RE: 125 Sumner Street
Project Revisions

Please find the cover letter in support of the exhibits provided for 125 Sumner Street (plans by The Architectural Team, Inc. dated April 25, 2017 and landscape design exhibits by Halvorson Design Partnership dated April 27, 2017). These exhibits reflect revisions made since the last BPDA design meeting.

Additional revisions are canonized in the below response to the March 17, 2017 memo from Matthew Martin. In italics are the comments from the memo followed by the response.

Site Plan - Revised

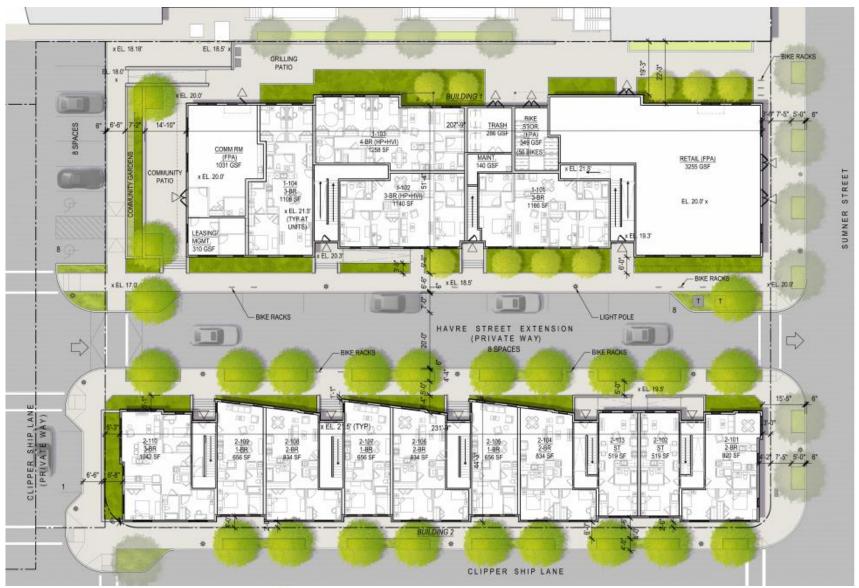
2.) The landscaped planting beds that run along the sidewalks on Sumner and Jacobbe have yet to be fully designed. Once compliant sidewalks have been added a fresh look should be taken for what can happen in these zones. Transformers, gas meters etc. should all be relocated to less visible locations either midblock on elsewhere for building 2. Consider an inside notch in the building or an otherwise less visible location. The raised planter along the edge of the outdoor patio for building 1 should be at least 5' in width in order to accommodate plantings that will be viable long term.

To accommodate the transformers, one parallel parking space located near Sumner Street was eliminated. This will allow for the transformers to be located above the flood elevation without having to berm the transformer pad; and will also allow for some adjacent plantings. The planting bed at the south of the Commons Patio is proposed to accommodate the community garden plots. This location from the west side of Building 1 will provide considerable more sunlight. The landscape architect shall provide images for other planting beds around the site.

Proposed Streetscape Layout

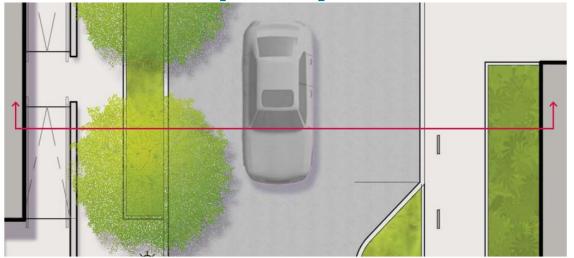
1.) Sidewalk widths are either not shown (Sumner St.) or under the complete streets minimums as shown along Jacobbe Way. All sidewalks within the project scope must meet complete streets standards

Sidewalks indicated on the revised plans meet Boston Complete Streets guidelines. The sidewalk condition along the Havre Street extension has been revised to maximize planting areas. In lieu of providing minimal tree beds on each side of the street, a single more generous bed has been proposed on the east side. The revised configuration also increases the minimum planting beds depth from Building 1 to the Havre Street extension sidewalk from 4'-0" to 6'-0".

- Street Trees: The street trees along the Havre Street extension have been reconfigured to be located on only on the east side. Benefits: 1) allows for deeper tree pit/planting zone, which helps long-term viability. 2) trees are not subject to swinging car doors and landscape zone less likely to be subject to foot traffic.
- **Transformer relocation:** one parallel parking space closest to Sumner Street has been eliminated in order to accommodate transformers. Benefits: 1) transformer pads are now above the flood elevation without having to berm up, 2) there is more room for plantings adjacent to the transformers than the previous locations.

Ground Floor Plan - Revised

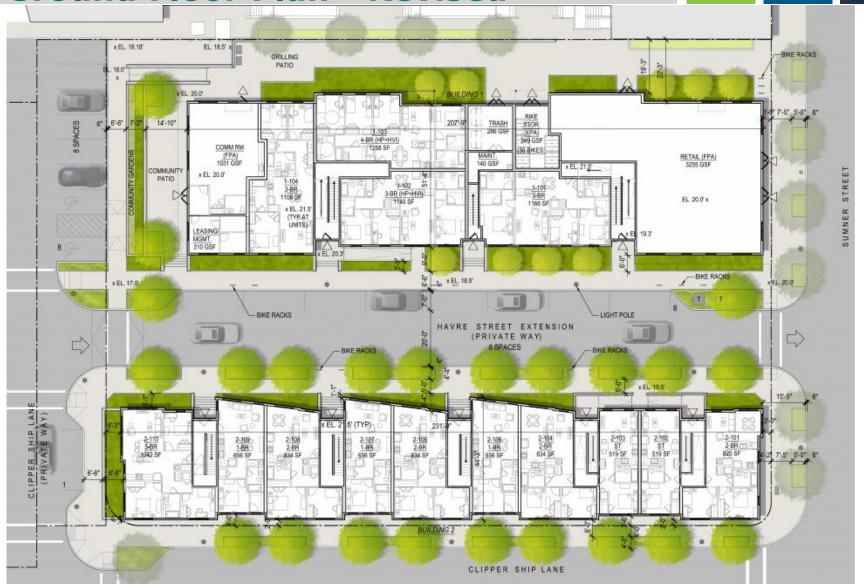
3.) Due to the limited space available for sidewalks along Havre Street, the outdoor access ramps provided for building 1 should be either incorporated inside the building or possibly setback away from the edge of the sidewalk to allow for a more generous sidewalk condition at the two entry points to the building. In either case, a more generous sidewalk beyond the minimum requirements of Complete Streets should exist in front of the entrances. Furthermore, the ramps proposed for Building 2 near Sumner Street should be moved away from the corner and possibly combined so as to limit their length along the public sidewalk.

4.) Building 1 in plan is essentially a long rectangle, and we'd like to have you break up the mass of the building by setting the middle section of the building back several feet. The building has already been architecturally broken into three parts along Havre St. so this would follow along with the existing language of the building but also provide a more generous space for residents to ingress and egress at the building's two entrances.

5.) Building 1 currently does not have a unique floor plan to allow for more windows for the end units facing Sumner and Jacobbe road. It's important that the end units have a more formal "front" building facade not only on Havre and Clippership Lane, but also addressing the busier streets at the ends of the block.

At Building 1, the revised configuration allows for more space from the sidewalk to the resident entries. At Building 2, modifications to the building interior to accommodate interior ramps has reduced the required the exterior ramp length. The assembly of the ramps at this location has been re-oriented to be integrated into the architectural design with its location directly below the projecting bay above.

This has been addressed by pushing the central section of the Building back by 3'-0". This not only further breaks down the massing but also provides a planting buffer between the sidewalk and entrance ramp and provides more space between the sidewalk and resident entries. An additional stoop entry has been incorporated to provide access to the added units located on the upper floor.

The 2-BR unit layout closest to Sumner Street has been modified to allow for an additional window at the kitchen. At the 3-BR unit located at the south, additional windows were provided both at the kitchen and at the projecting corner element.
